Preservation Department – Item 2, LPC-25-03831

**1143 Fifth Avenue – Expanded Carnegie Hill Historic District
Borough of Manhattan**

ROOFTOP ADDITION AND FAÇADE RESTORATION
LANDMARKS PRESERVATION COMMISSION

LPC PRESENTATION | MARCH 4, 2025

WEST ELEVATION

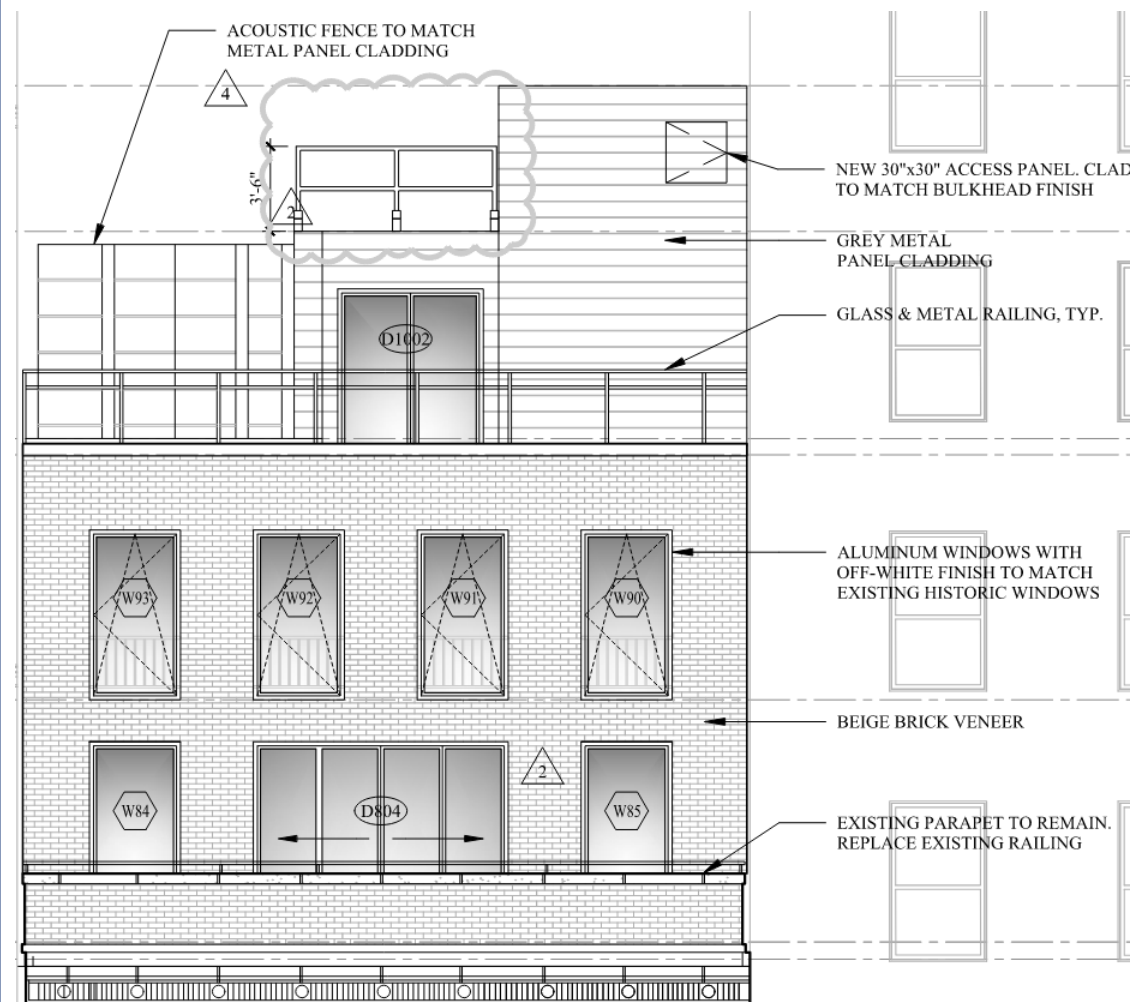
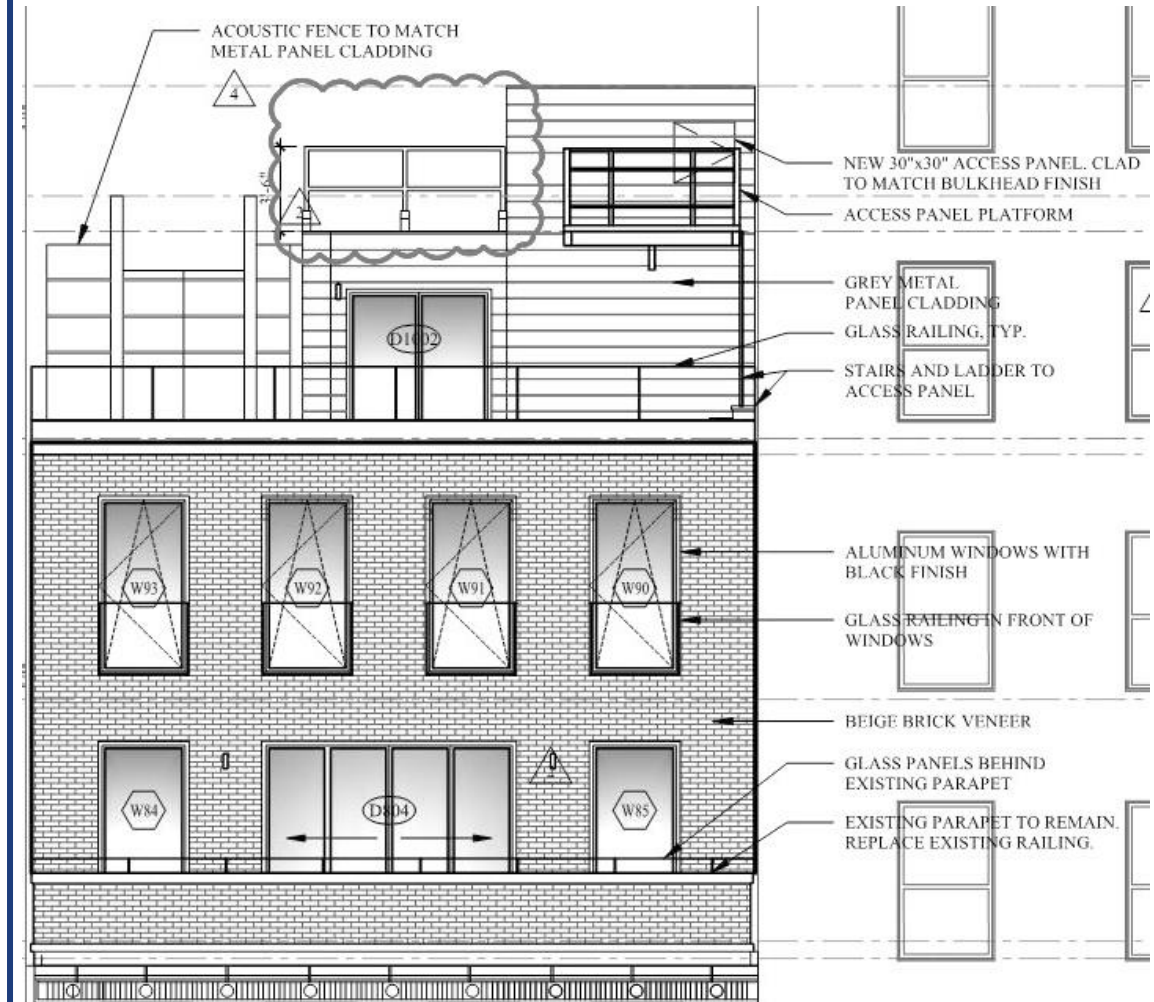
- 7TH & 8TH FLOOR PENTHOUSE WINDOWS & DOOR FINISH COLOR CHANGED FROM OFFWHITE TO BLACK.
- 8TH FLOOR WINDOW GUARDS CHANGED FROM METAL PICKET RAILING TO GLASS RAILING.
- 8TH FLOOR ROOF GLASS GUARDRAIL CONFIGURATION CHANGED SLIGHTLY. GLASS GUARDRAIL IS FRAMELESS WITH A METAL SHOE AT BASE. OVERALL GUARDRAIL IS A FEW INCHES CLOSER TO THE FRONT WALL OF THE PARAPET AND A FEW INCHES TALLER THAN ORIGINALLY APPROVED.
- 9TH FLOOR WINDOWS – THE SILLS OF THESE WINDOWS ARE APPROXIMATELY 12 INCHES ABOVE THE 9TH FLOOR LEVEL. THESE WINDOWS WERE ORIGINALLY APPROVED TO HAVE SILLS ALIGNED WITH THE FLOOR ELEVATION."

ROOFTOP TERRACE GLASS RAILING DETAIL

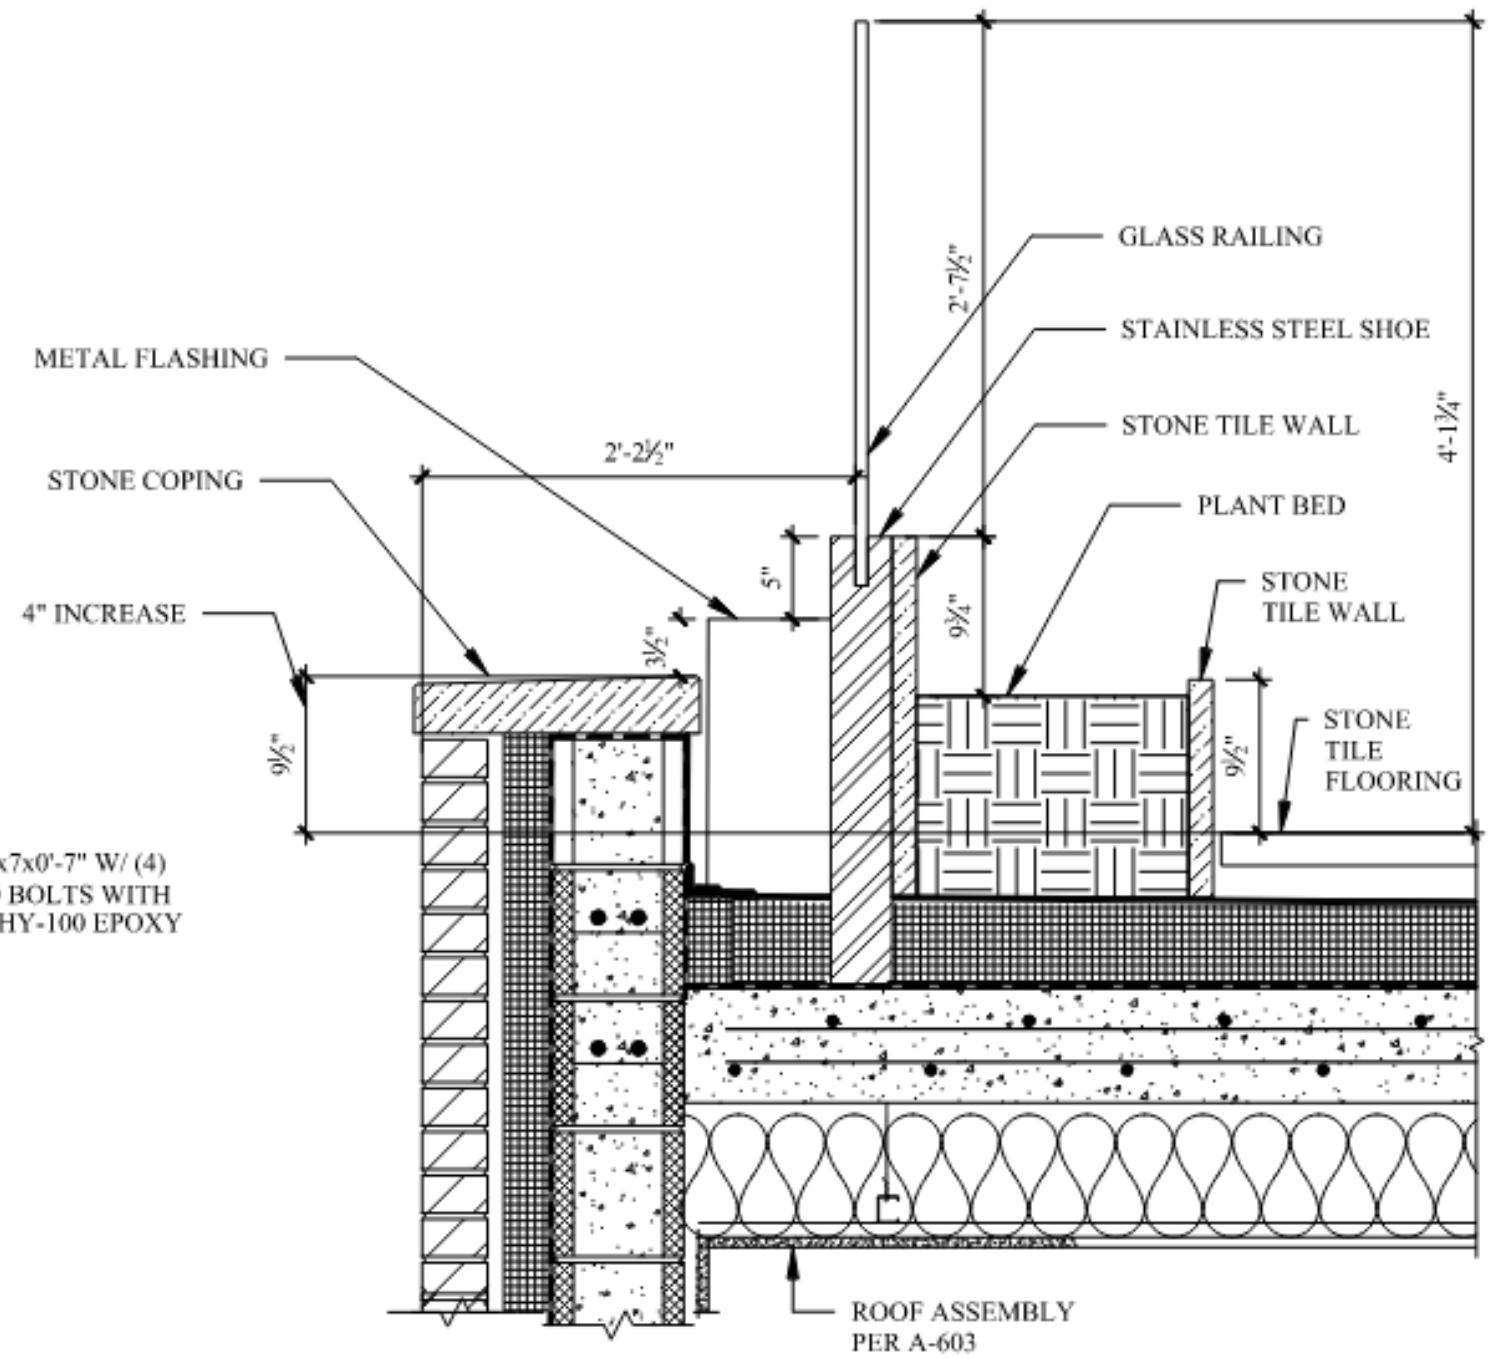
PROPOSED PENTHOUSE RAILING DETAIL

AS- BUILT PENTHOUSE RAILING DETAIL

PENTHOUSE GLASS RAILING LOCATED IN
FRONT OF 8TH FLOOR WINDOWS

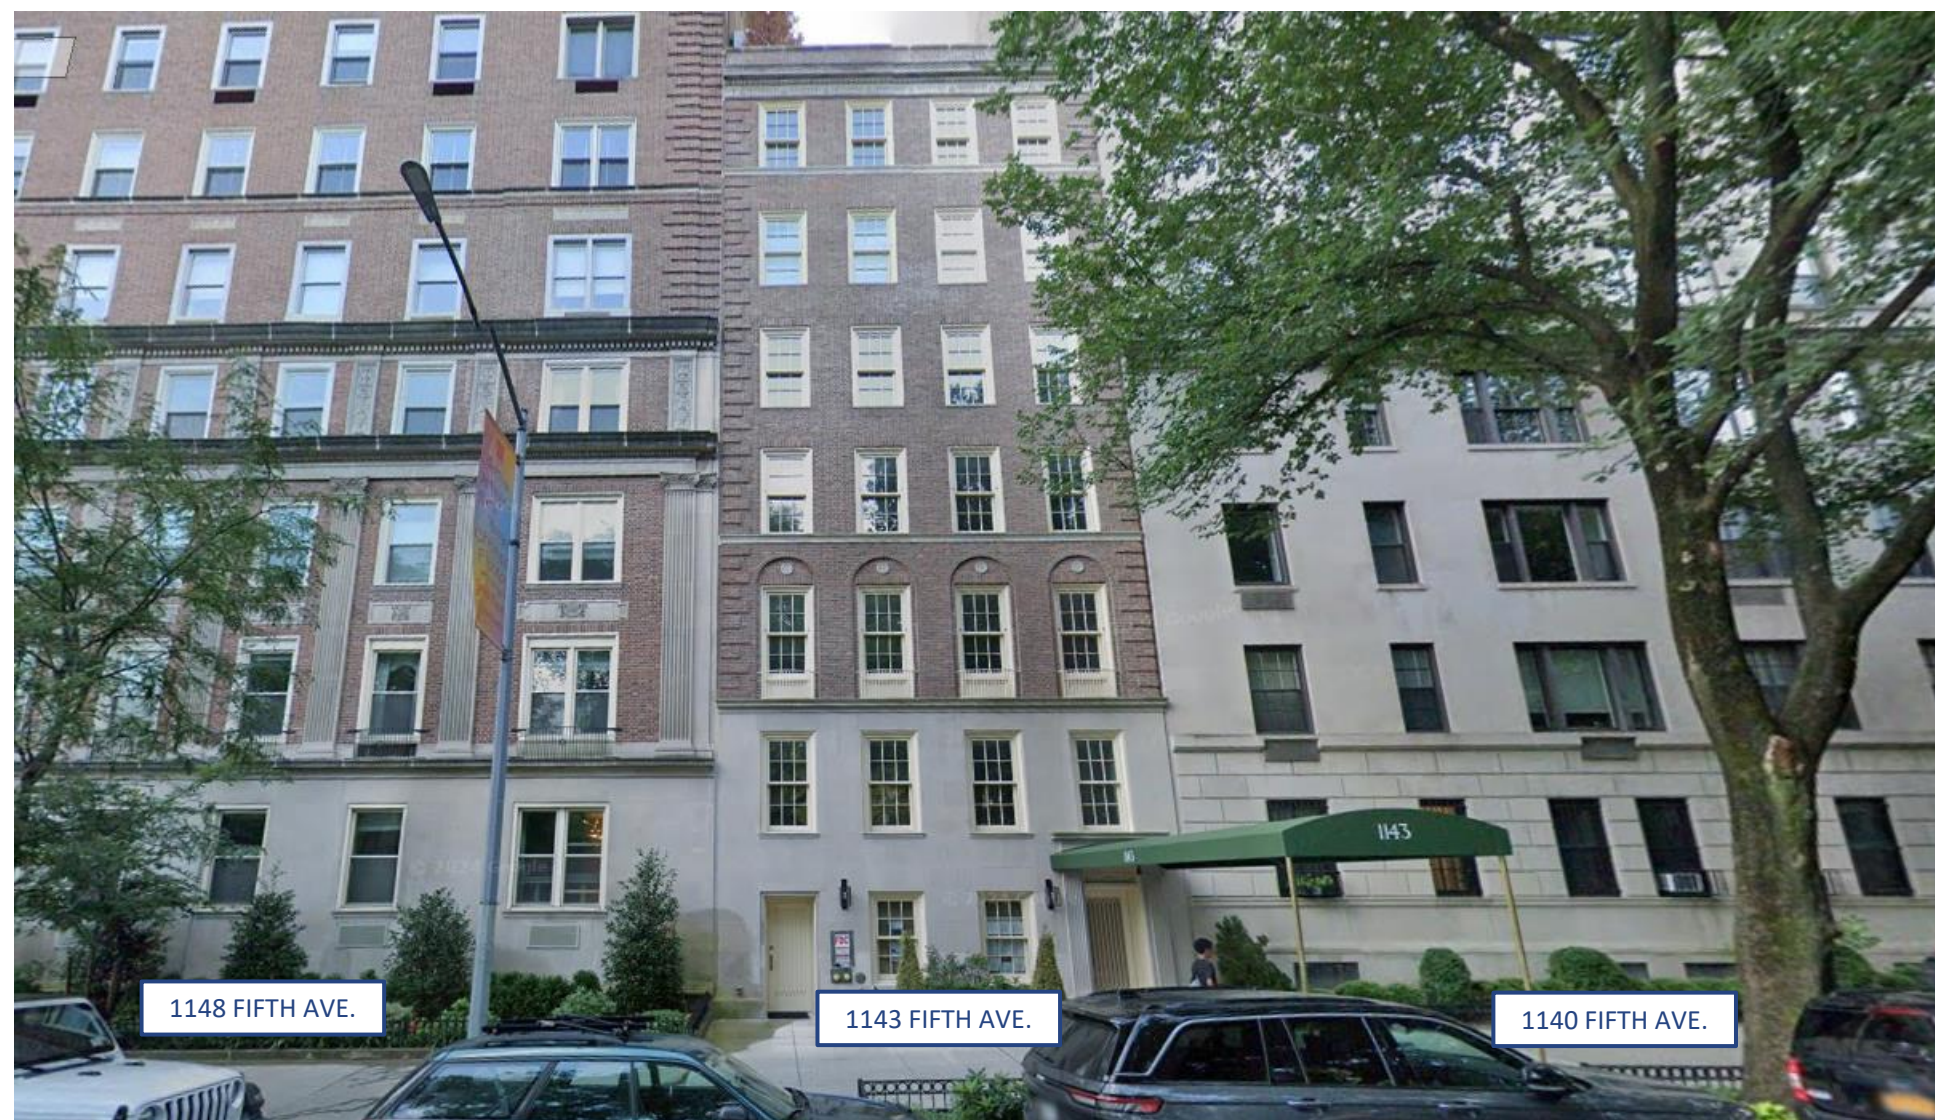
AS BUILT PENTHOUSE WINDOWS WITH BLACK TRIM

AS BUILT PENTHOUSE WINDOWS WITH GLASS RAILING
